Access Compliance Report

Public Rights-of-Way

Intersection ID: 44723	Main Street: PROSPERITY_CHURCH_RD	Cross Street: JOHNSTON_OEHLER_RD	Location: SE
ADA ID: F518FA8B9907	Ramp Type: IslandPerp	Initial Pass/Fail: Fail	Overall Compliance: No
		Severity Score: 25

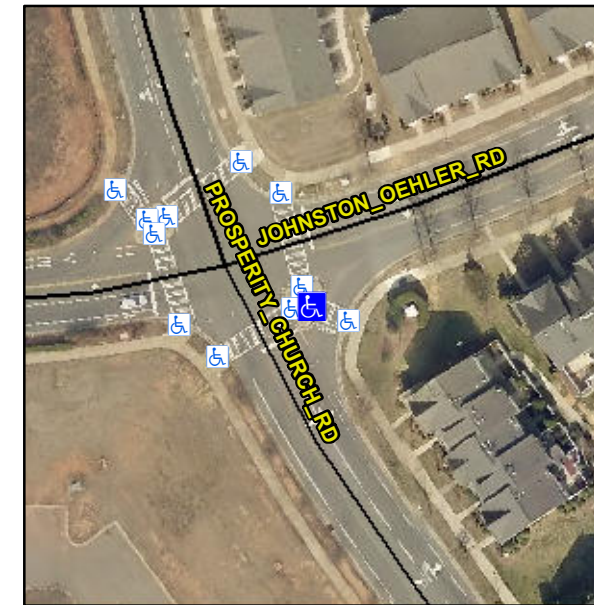
R304.2.2

Compliance	Description	Data	Compliance	Description	Data
N/A	Ramp Length (in)	60.0	No	Ramp Slope (%)	12.5
Yes	Ramp Width (in)	77.0	Yes	Ramp XSlope (%)	0.6
N/A	Flare Type LT	N/A	N/A	Flare Type RT	N/A
N/A	Flare Slope LT (%)	N/A	N/A	Flare Slope RT (%)	N/A
N/A	Flare Traversable LT?	N/A	N/A	Flare Traversable RT?	N/A
N/A	Landing Length (in)	N/A	N/A	DWS Provided?	N/A
N/A	Landing Width (in)	N/A	N/A	DWS Contrast?	N/A
N/A	Landing Slope (%)	N/A	N/A	DWS Length (in)	N/A
N/A	Landing X Slope (%)	N/A	N/A	DWS Full Width?	N/A
N/A	Landing Curb? (Y/N)	N/A	N/A	DWS Offset (in)	N/A
N/A	Shared Landing?	N/A			
N/A	Gutter Ponding?	N/A	N/A	Gutter Slope (%)	N/A
N/A	Gutter Lip Ht (in)	N/A	N/A	Gutter X Slope (%)	N/A
N/A	Painted X Walk1?	Yes	N/A	Painted X Walk2?	N/A
	X Walk 1 Direction	To SE		X Walk 2 Direction	N/A
N/A	X Walk 1 Width (in)	112.0	N/A	X Walk 2 Width (in)	N/A
	X Walk 1 Slope (%)	2.0		X Walk 2 Slope (%)	N/A
	X Walk 1 X Slope (%)	1.6		X Walk 2 X Slope (%)	N/A

Remove & Replace Entire Ramp.
